Hallsville School District

All Purpose Field & Parking Lot Primary School Classroom Addition Secure Entry Doors

Progress Report #1

SUPPLEMENTAL INSTRUCTION 1 (SI 1)

SHEET
C002

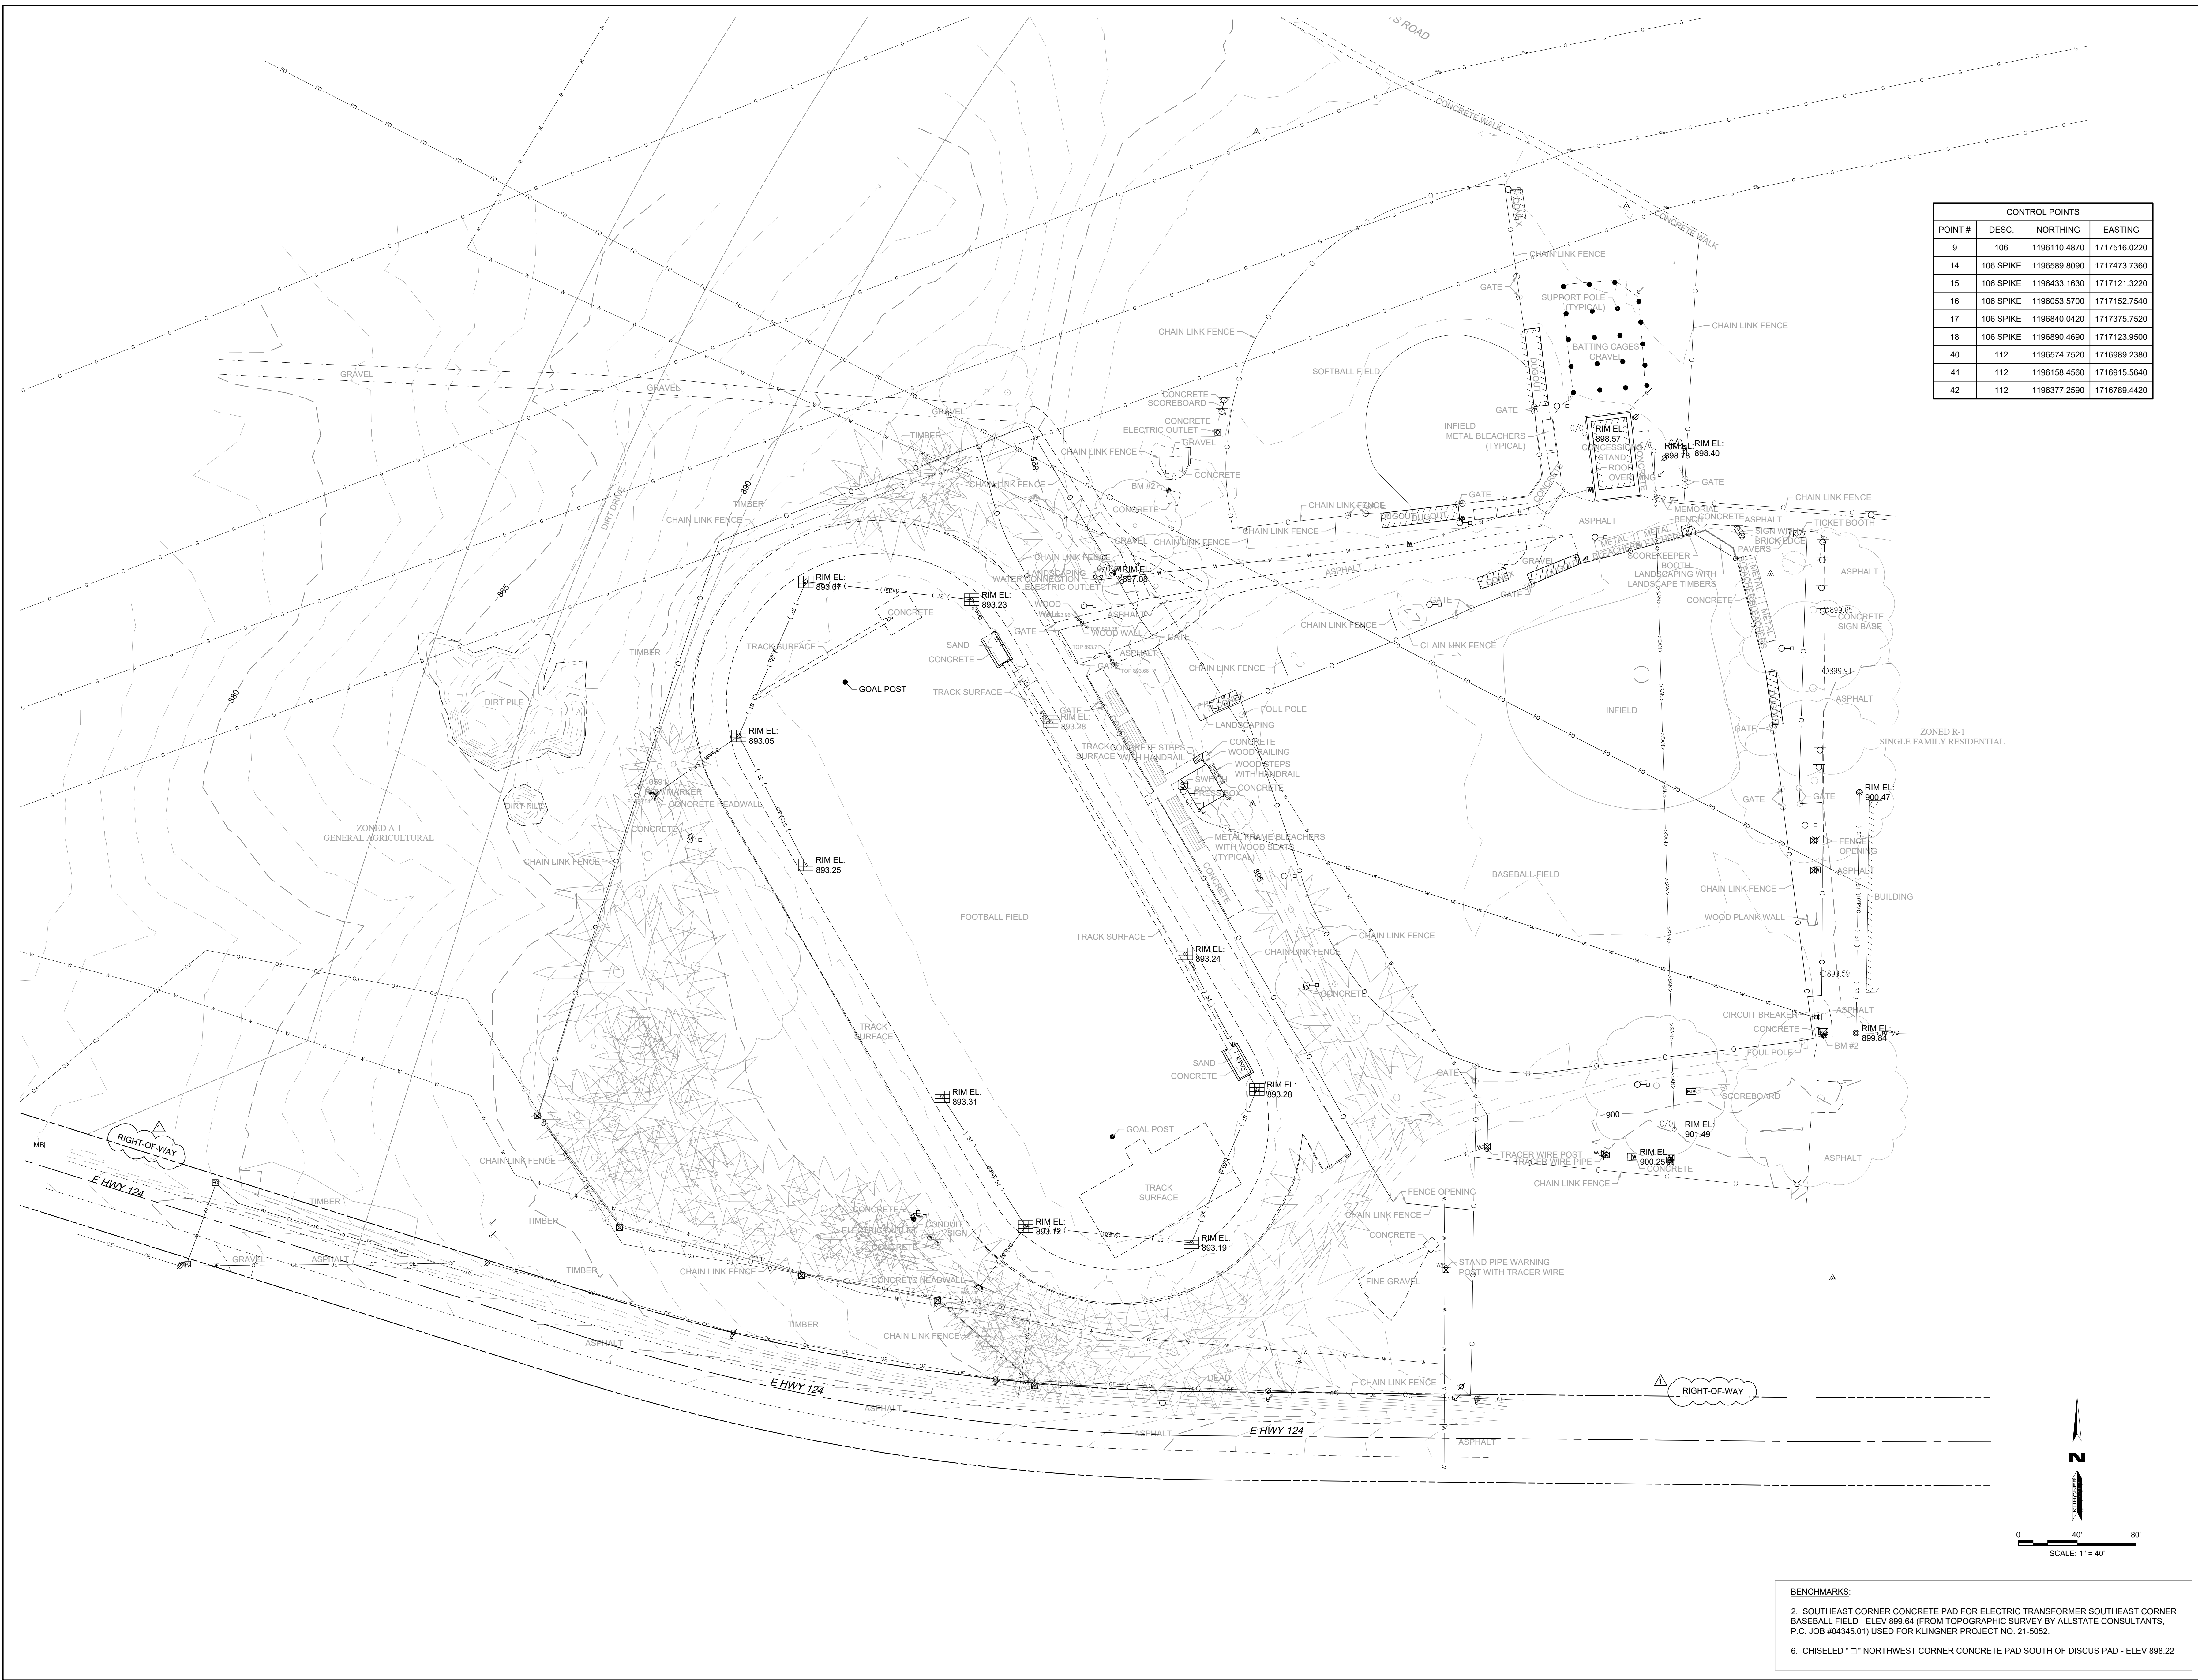
| 1 | Sheet C002 | Add Sheet C002 to provide required traffic control in accordance with the MoDOT entrance permit. |

PROJECT NO: 24-5017
 DRAWING ISSUED DATE: 11/14/2025
 SHEET
C100

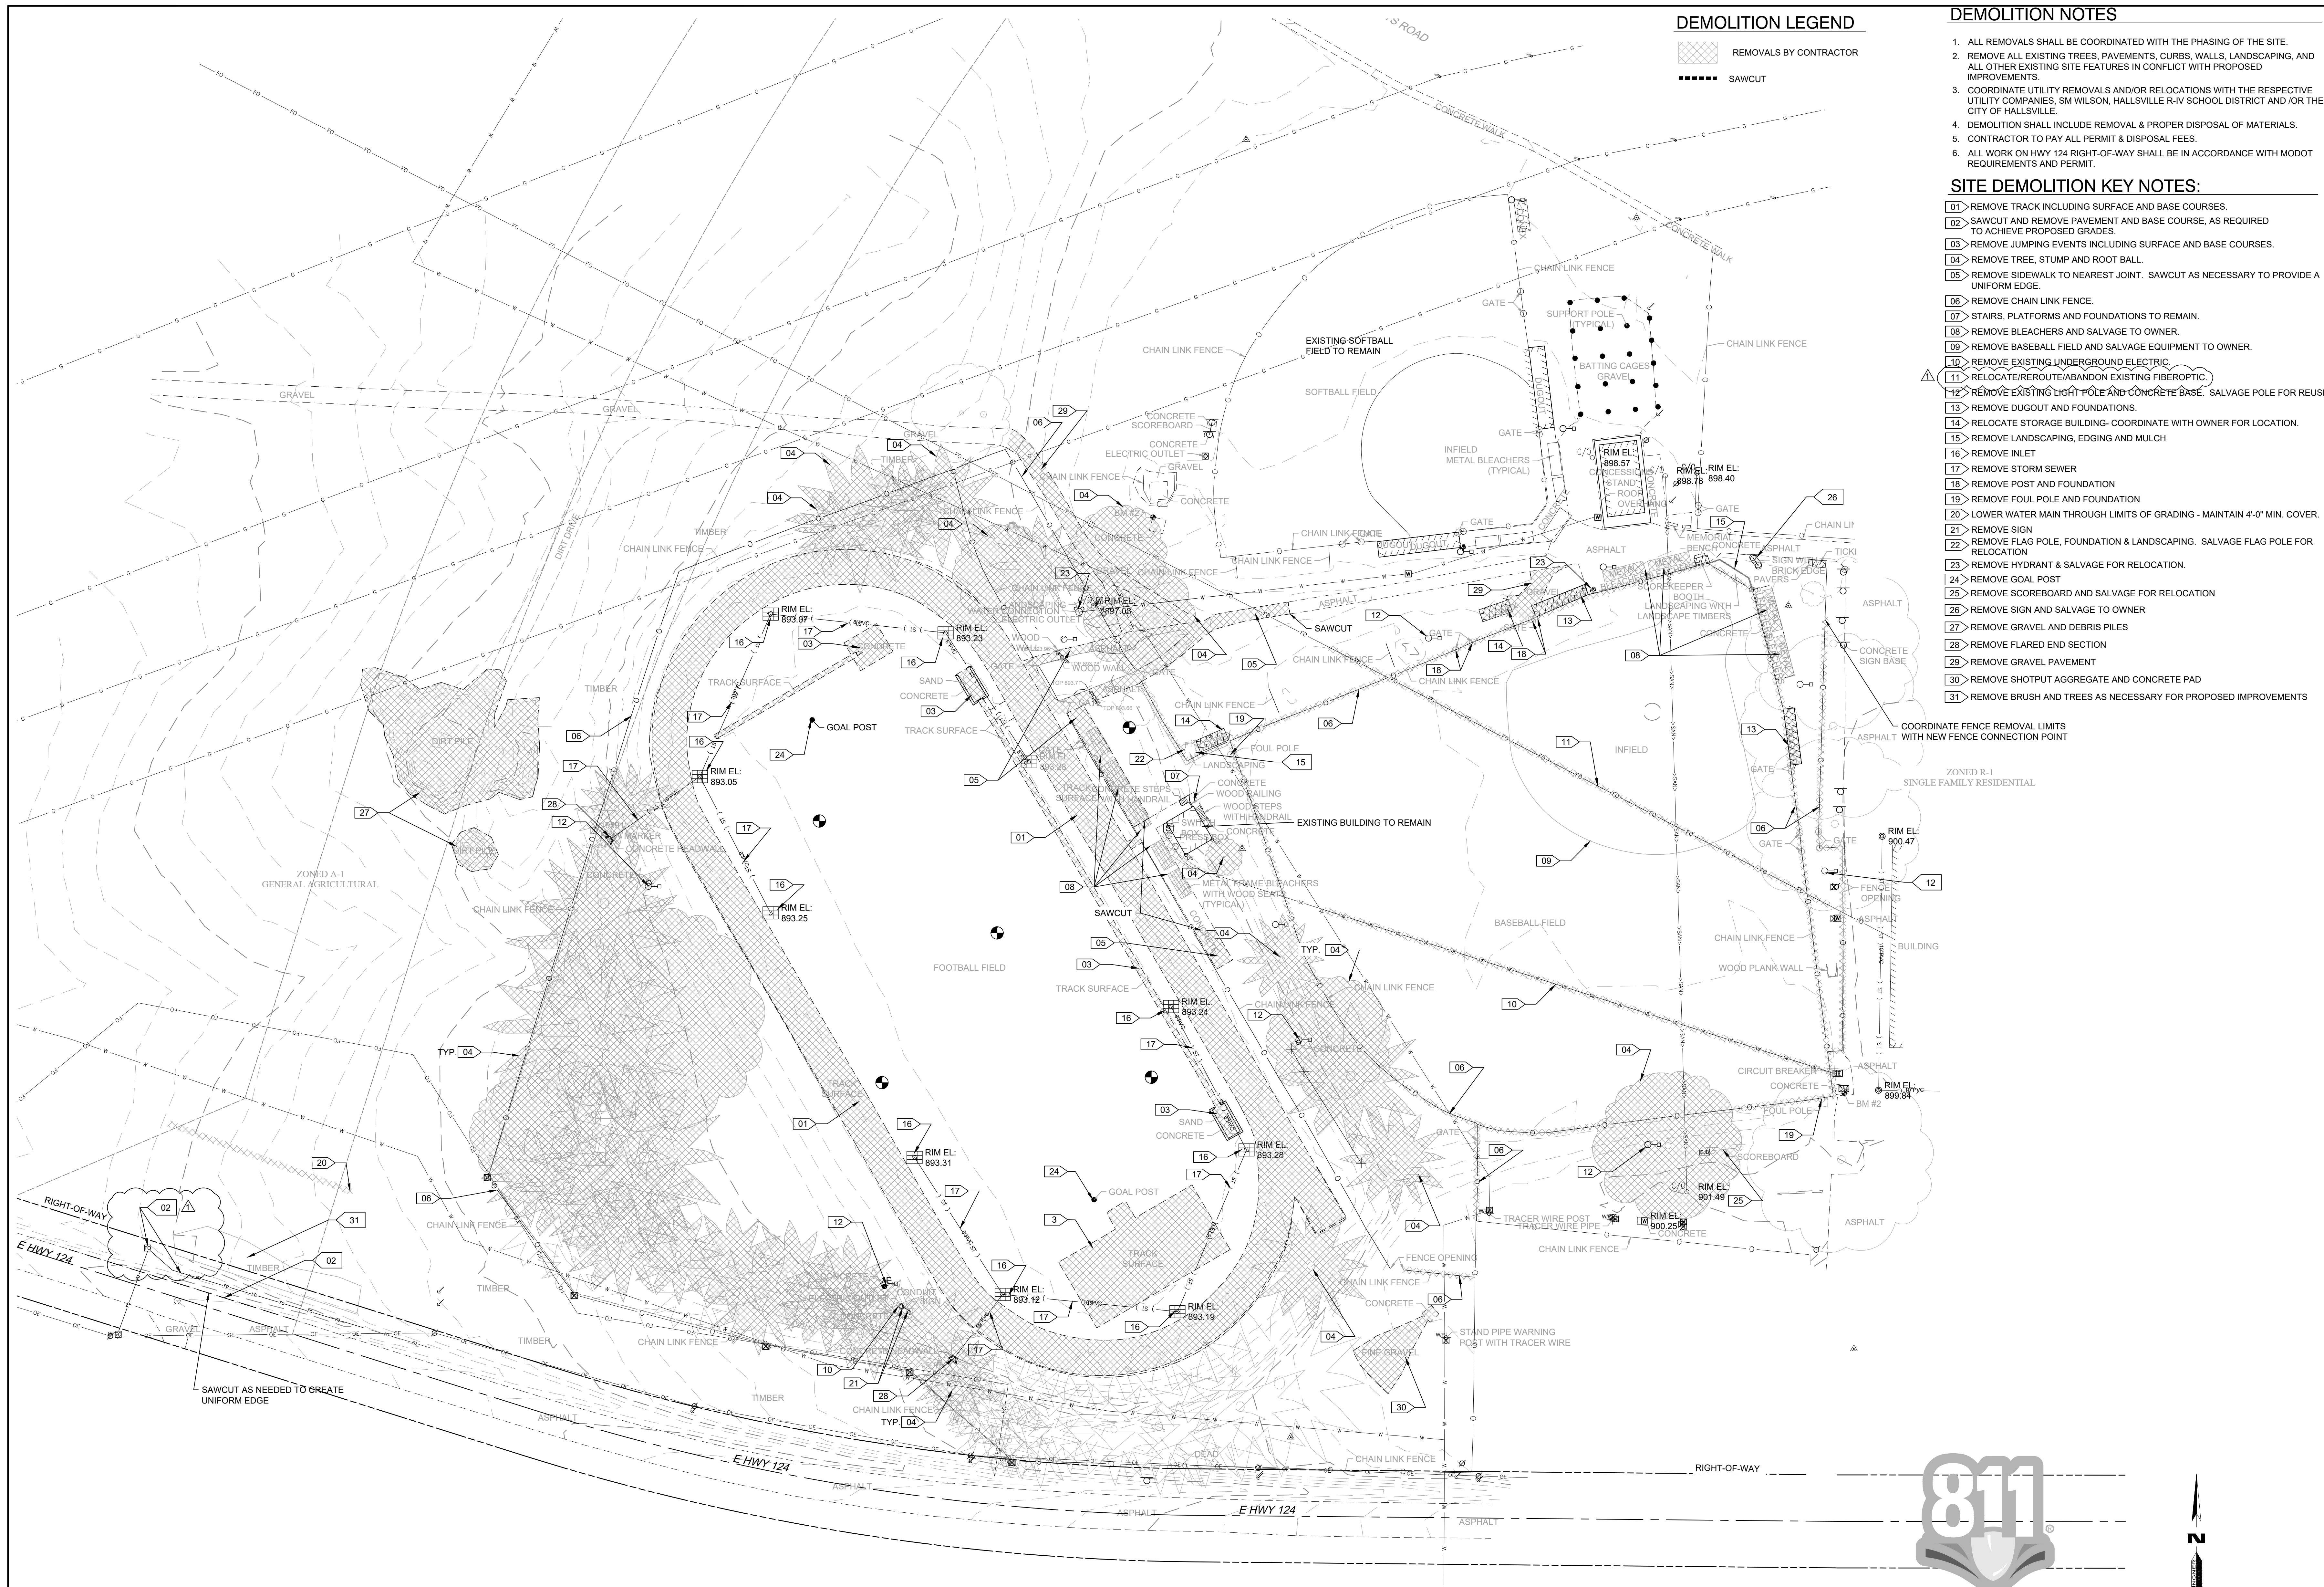
| 2 | Sheet C100 | Added Highway 124 right-of-way to this sheet. |

| REVISION HISTORY | | | |
|------------------|---------|--------------|-----|
| ADD | 1/21/26 | RIGHT-OF-WAY | DCD |

SHEET
CD101

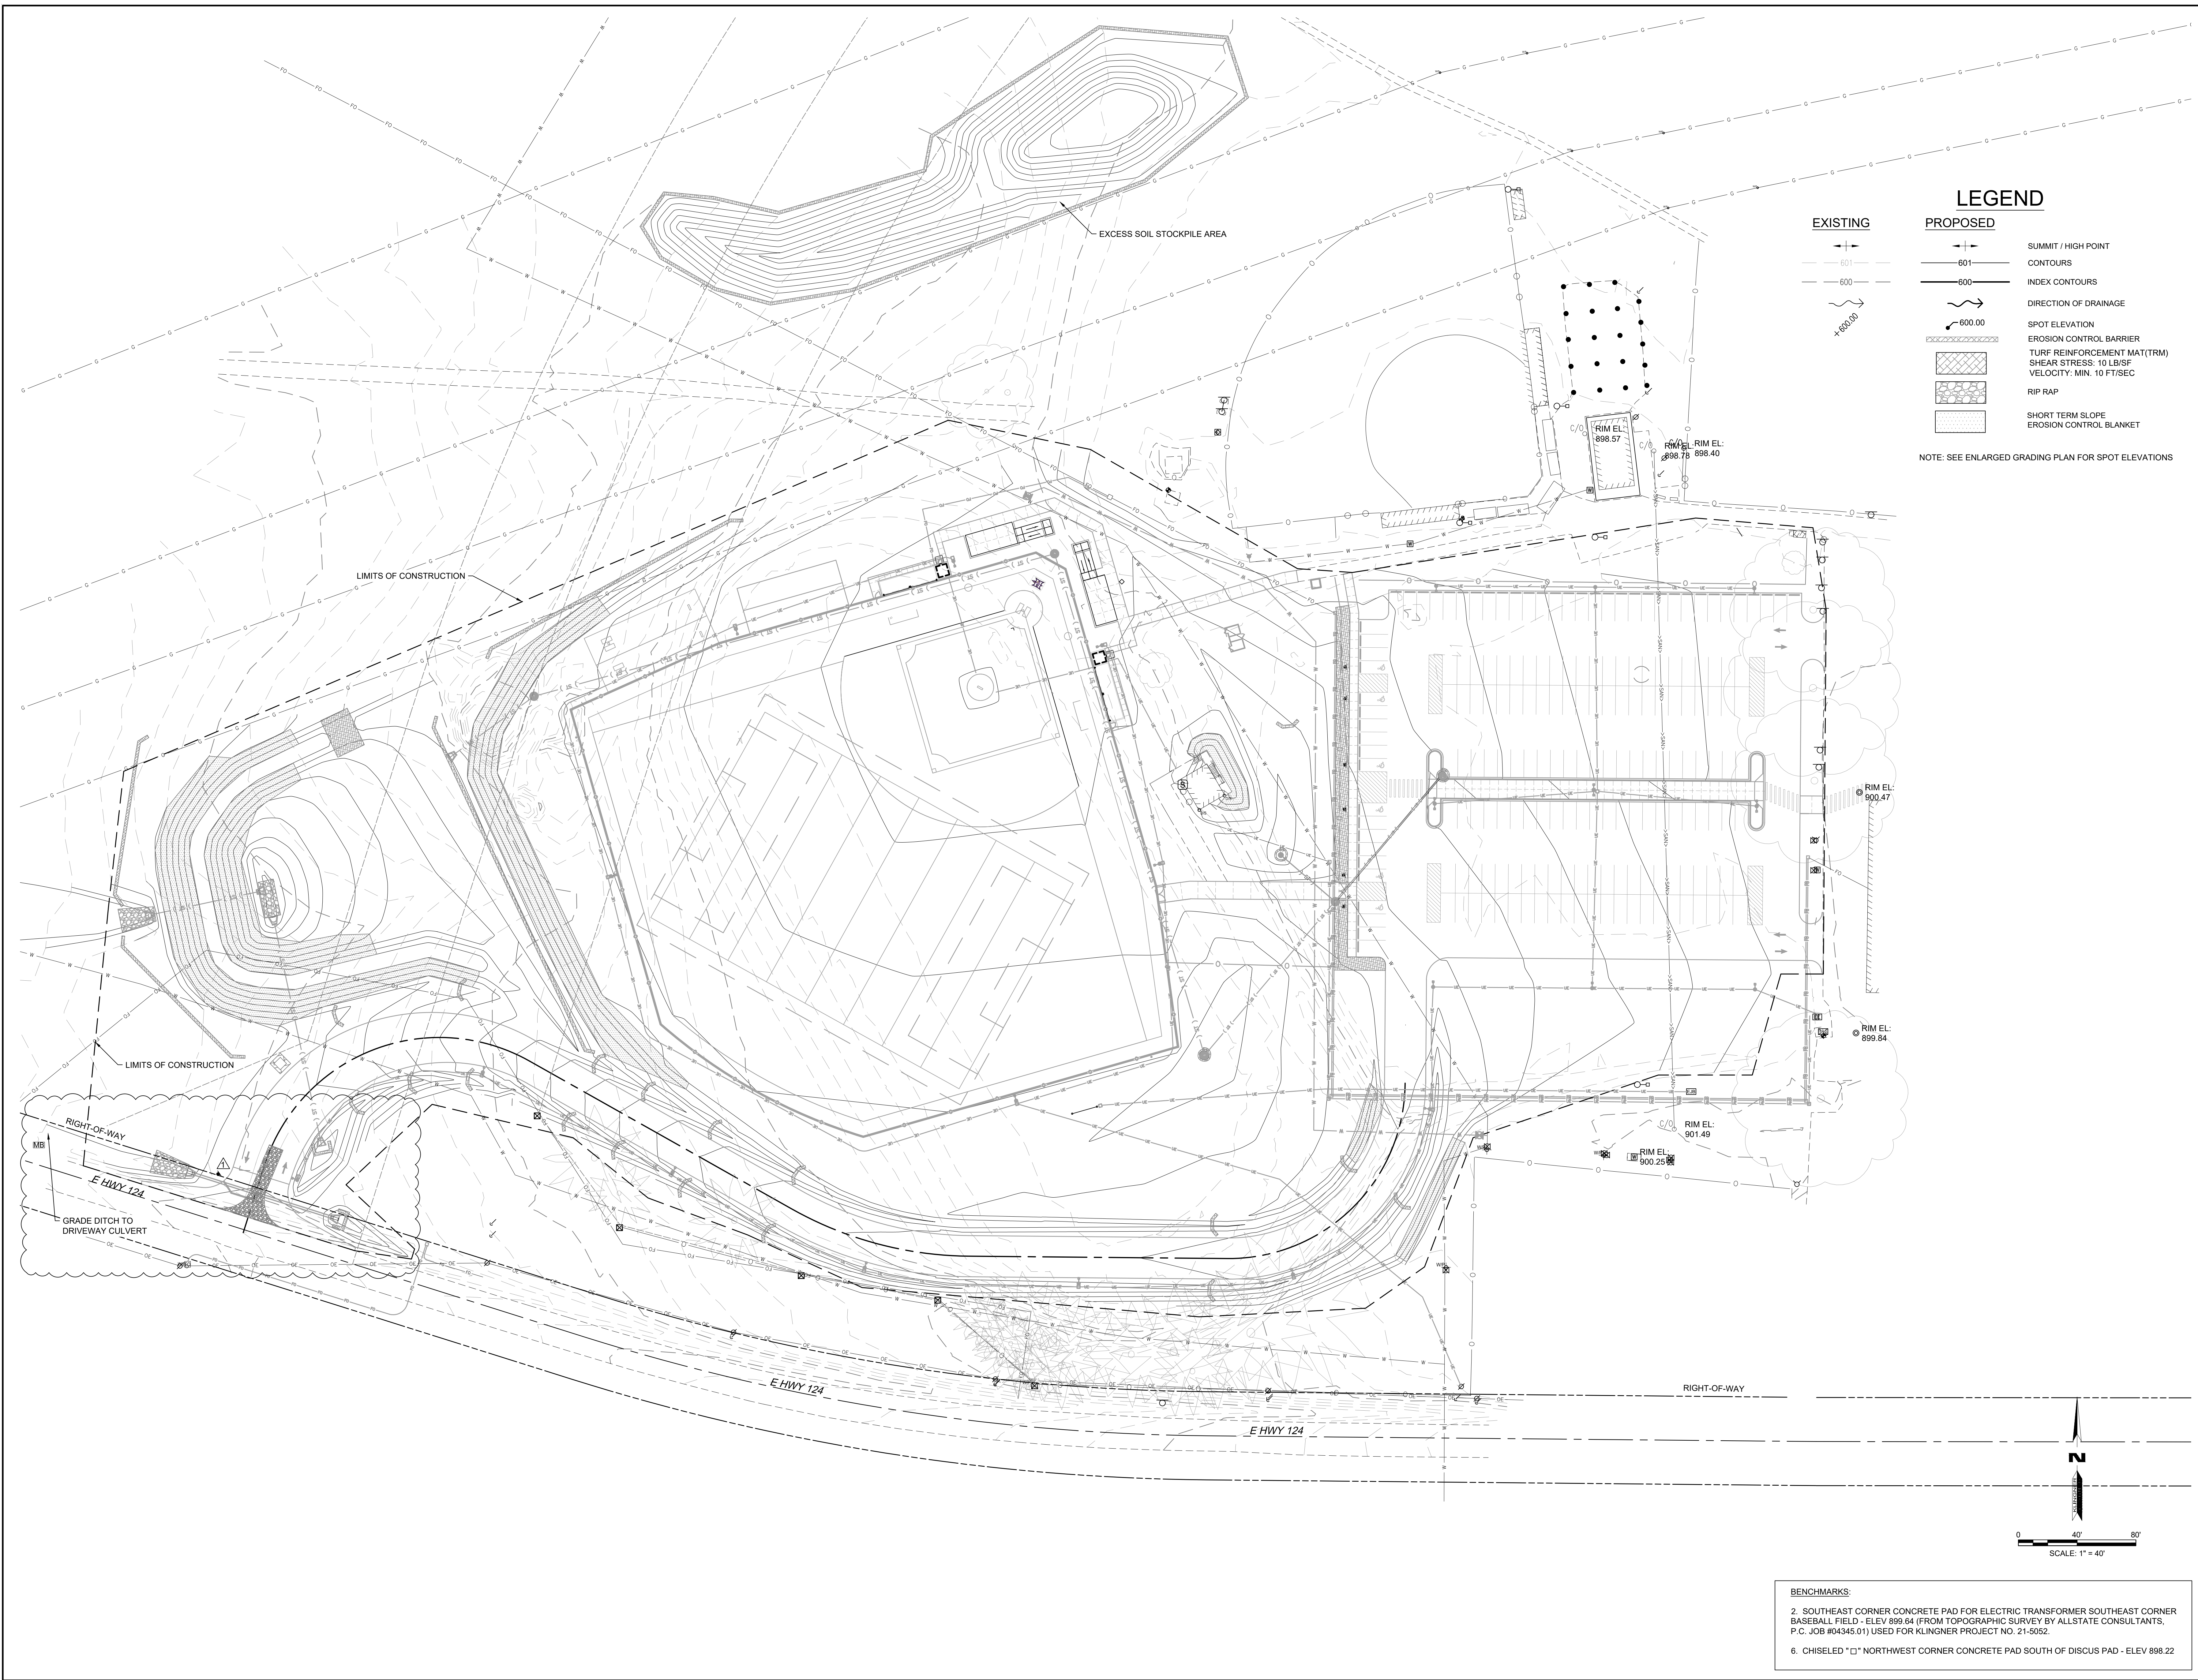
| 3 | Sheet CD101 | Add fiberoptic removal/abandonment at entrance. |

| NO. | DESCRIPTION | DATE |
|-----|------------------------------------|-------------|
| 2 | SHOW FIBER REMOVAL AT NEW ENTRANCE | 1/21/26 DCD |
